PCN-20240207 TE0821-01 Pull-up resistor removal for signal "MR"

Company	Trenz Electronic GmbH
PCN Number	PCN-20240207
Title	Pull-up resistor removal for signal "MR"
Subject	BOM Change
Issue Date	2024-02-07

#1 Pull-up resistor (R82) removal for signal "MR"

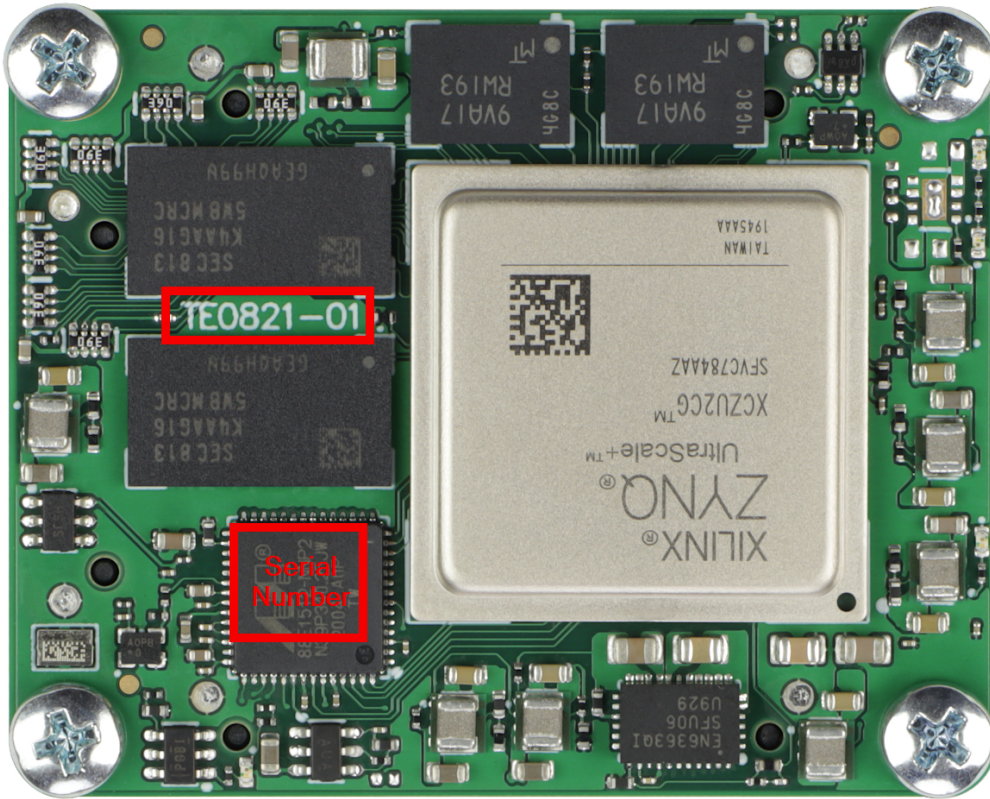
Type: BOM Change

Reason: Boot procedure improvement.

Impact: None, U19 has internal pull-up resistor. Improved boot procedure.
